Date: July 2023 Technical Bulletin T23.2

Farenhyt Series IFP-75, IFP-300, IFP-300ECS, IFP-2100 and IFP-2100ECS Fire Alarm Control Panels Firmware Compatibility Issue with SBUS Devices

006815 SLC Loop Expander Firmware Version Identified Here

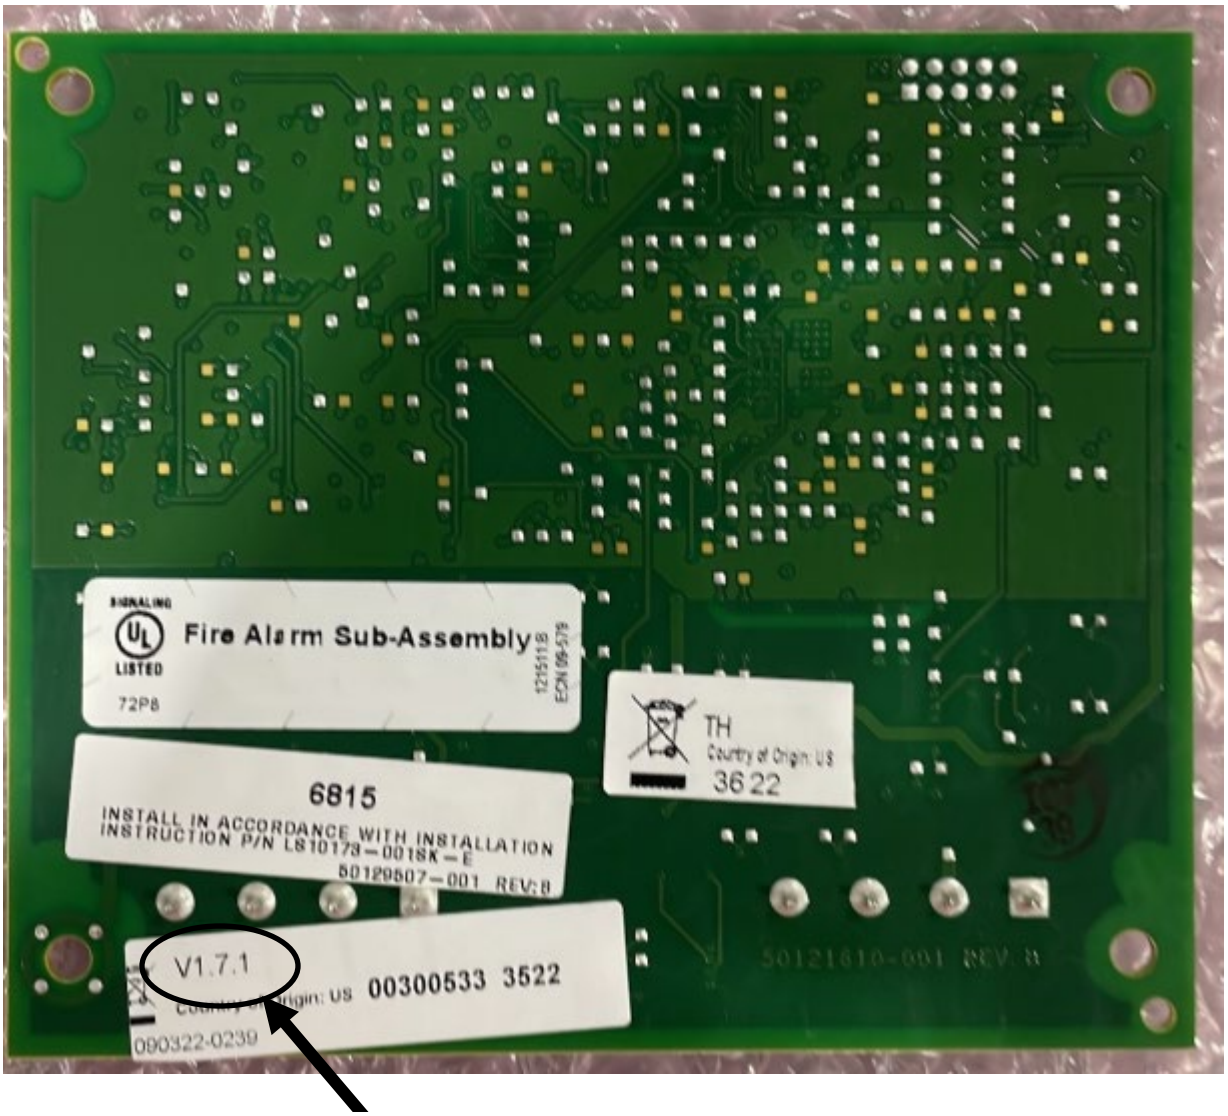
Note for Systems with 006815 SLC Expanders:
Systems with a 006815 SLC loop expander card using firmware version 1.7.1 and running FACP firmware version 7.00.08 will first need to downgrade their panel firmware to version 7.00.02 and then upgrade their FACP back to firmware version 7.00.08 in order to upgrade the 006815 SLC expander card to the latest firmware version 1.8.2. See the following page for help locating the firmware version of a 006815 loop expander card.
